GS# 103-317
University Pointe – Buildings 100 & 200
Jackson State University
Project Number: 2017-006

Addendum No. 2

14May2026

A-401R1

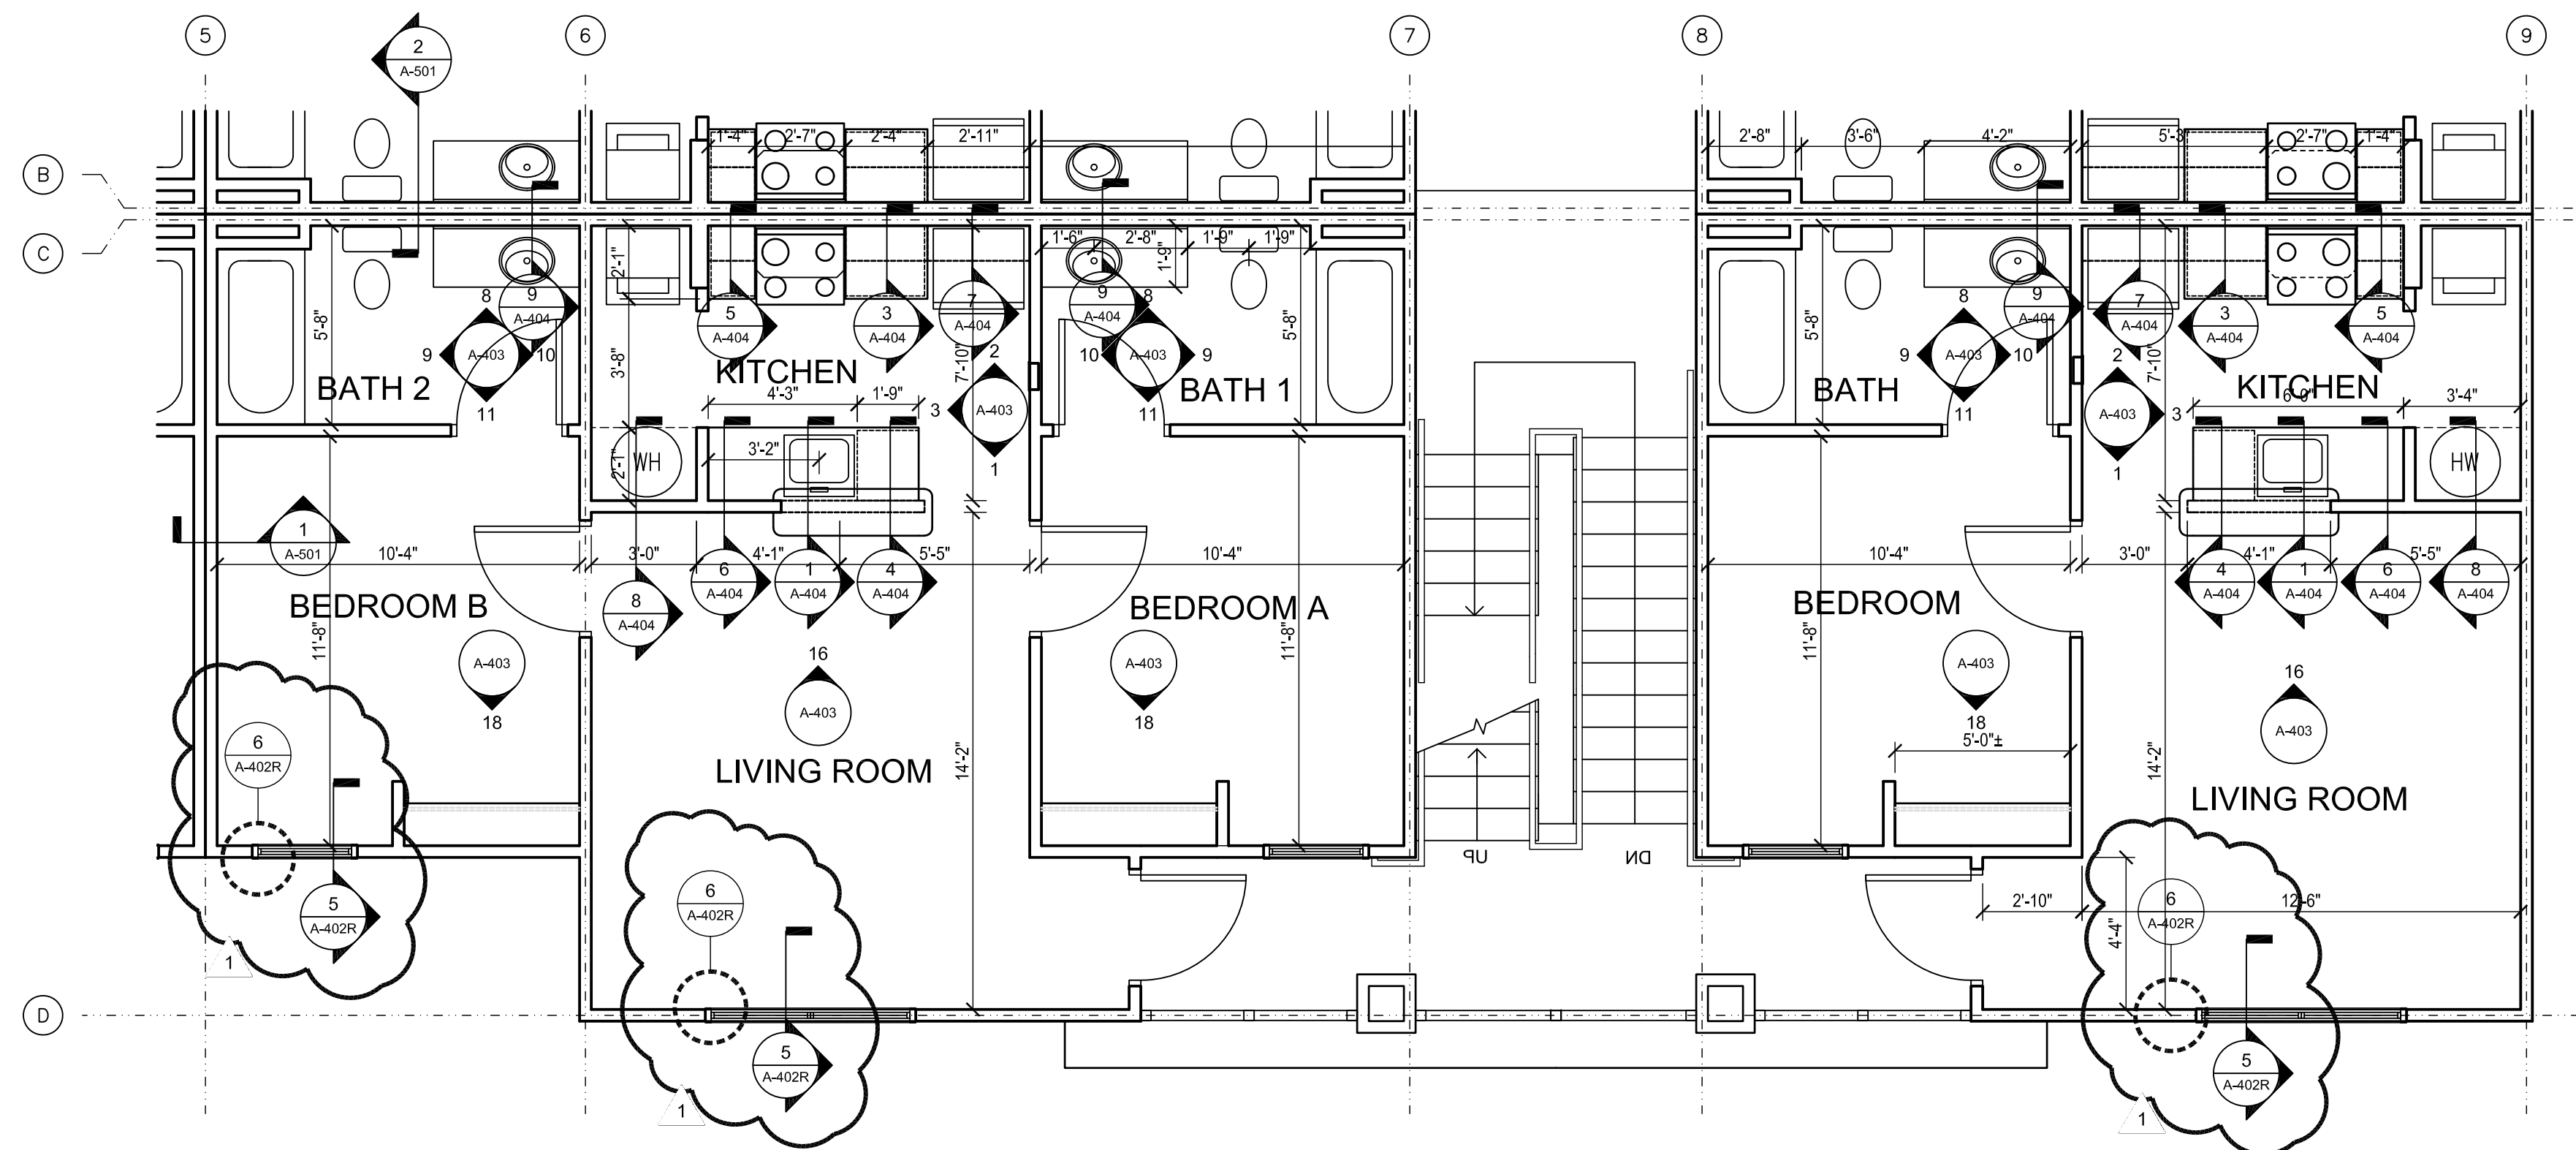
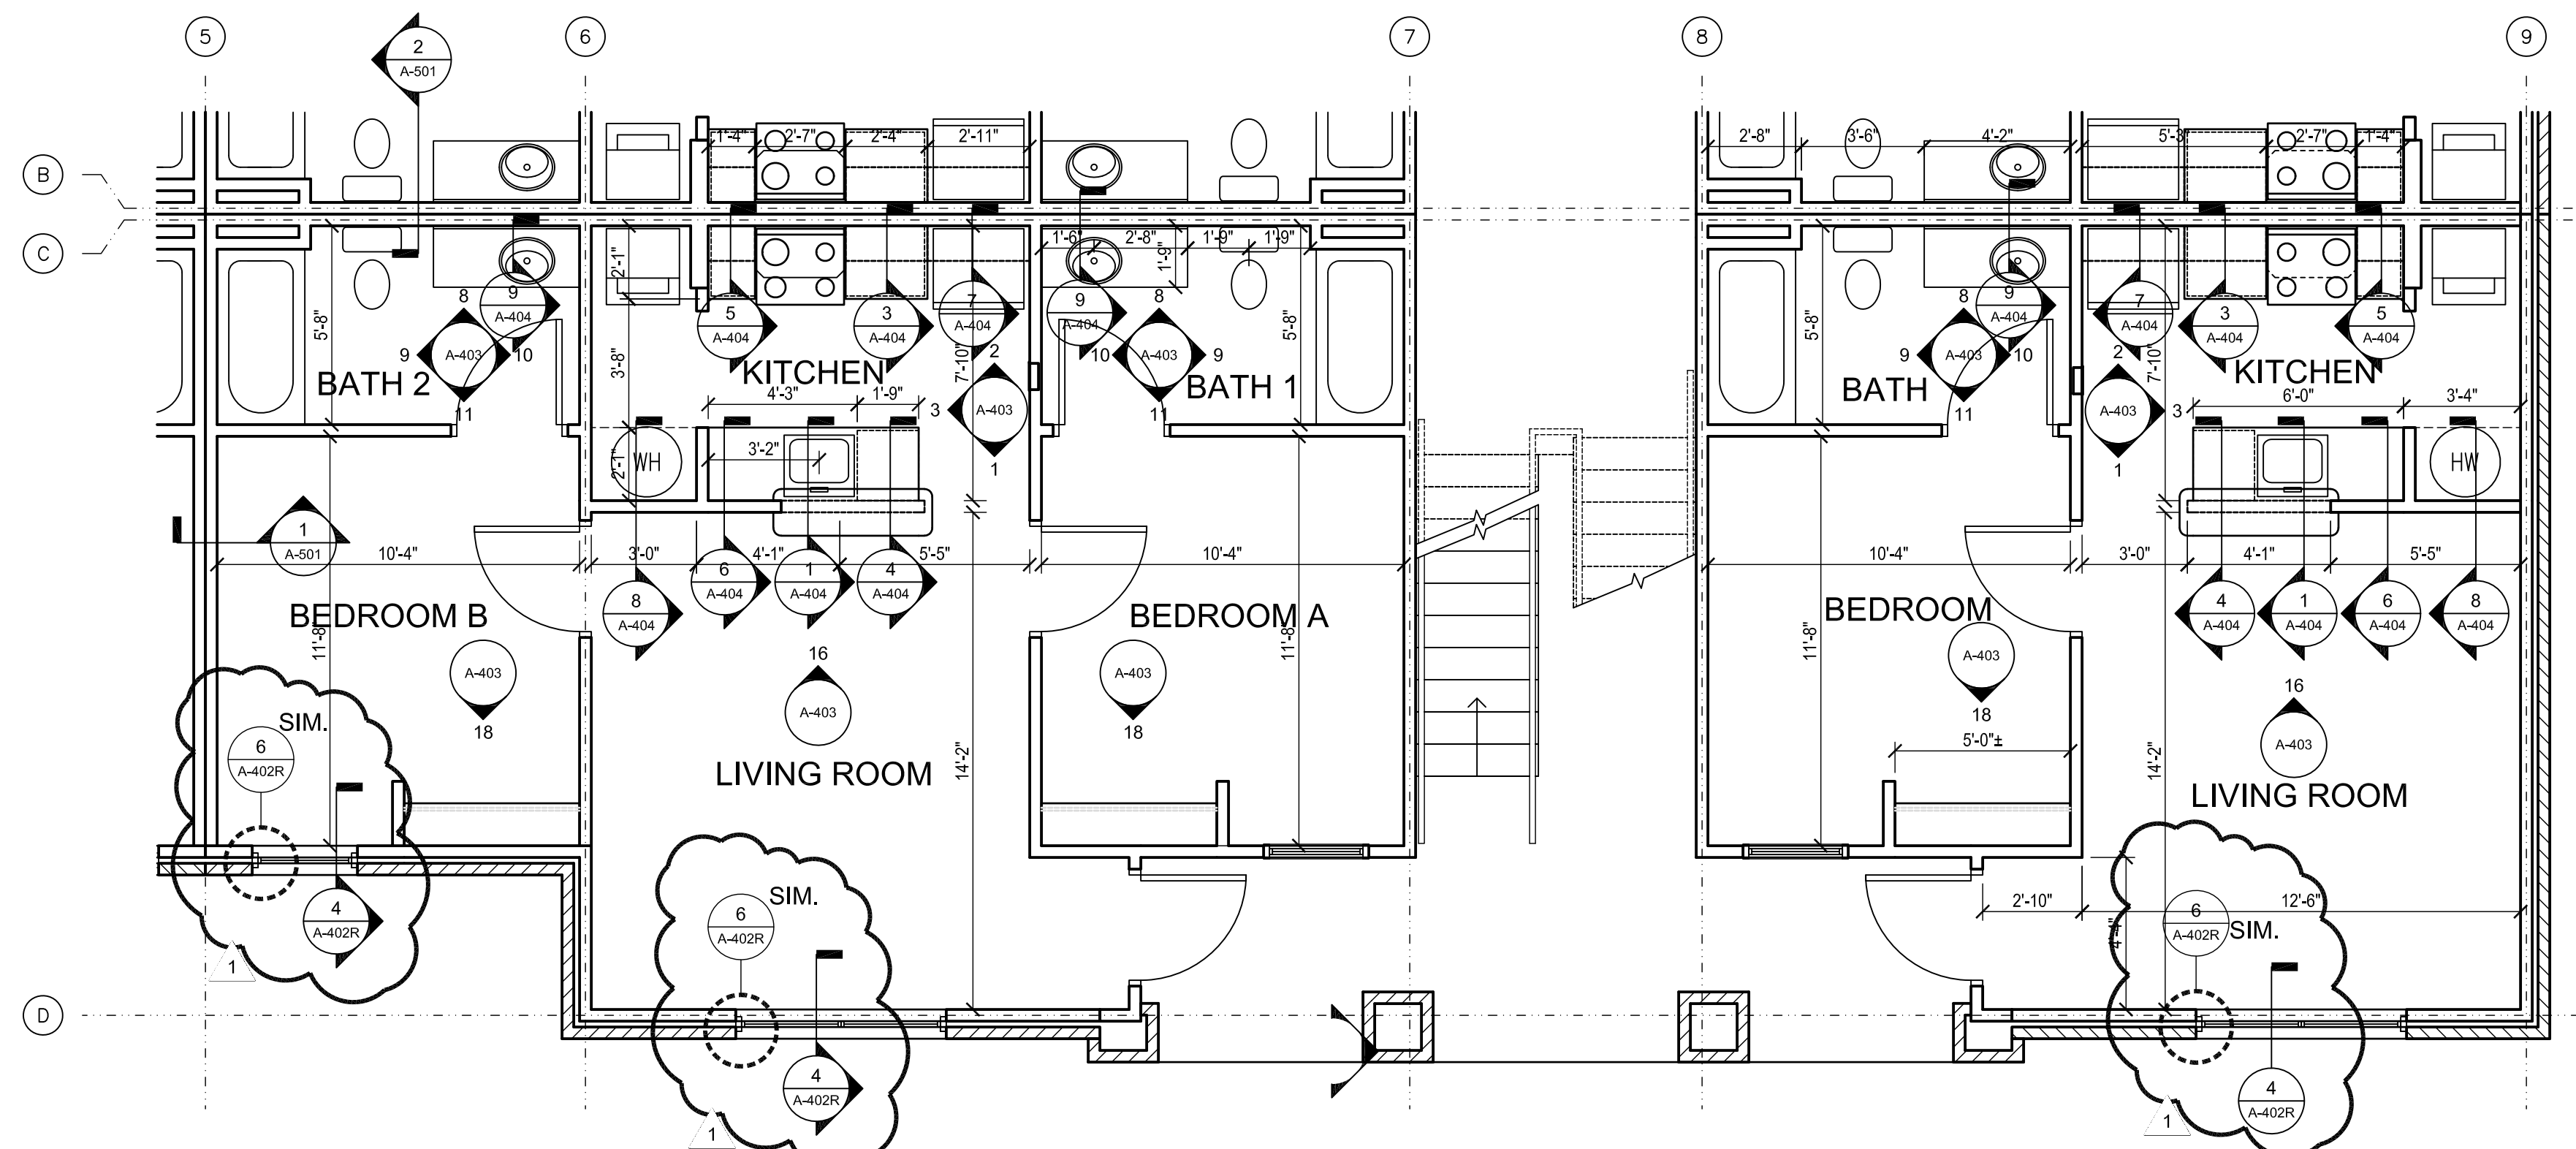
- Item No. 9 Sheet A-502.
- Add: A new drawing sheet has been created which will include details for the retrofitting of the balconies at building 200.
- Item No. 10 Sheets A-401R1 & A402R1.
- Revision: Revise paint sheen finish from Flat to **Eggshell** finish.
- Item No. 11 Sheets A-601R1 & A602R1.
- Revision: Revise door type “A” description from metal to wood.
- Item No. 12 Sheets T-101R
- Revision: Update the title sheet to include A-502 in the list of drawings.

- PROVIDE AS THE BASE BID LVT FLOORING THROUGHOUT LIVING AREAS, BEDROOMS, BATHS, KITCHENS, AND UTILITY AREAS, EXCEPT THE ADAPTABLE BATHROOM..
- ALL GWB IN THE LIVING AREAS SHALL RECEIVE AN EGGSHELL PAINT FINISH. ALL GWB IN THE BATHS SHALL RECEIVE PRIMER COAT AND FINISH WITH A COAT OF EPOXY PAINT.

- ALL INTERIOR WINDOW STOOLS SHALL BE WOOD AND PAINTED USING A PRIMER COAT AND SEMI-GLOSS FINISH.
- ALL WALL BASE (EXCEPT THE ADAPTABLE BATH) SHALL BE 4" HIGH WOOD AND SHALL RECEIVE A PRIMER COAT AND FINISH WITH SEMI-GLOSS PAINT.

- ALL WOOD TRIM AT DOOR FRAMES SHALL RECEIVE A PRIMER COAT AND FINISH WITH SEMI-GLOSS PAINT.
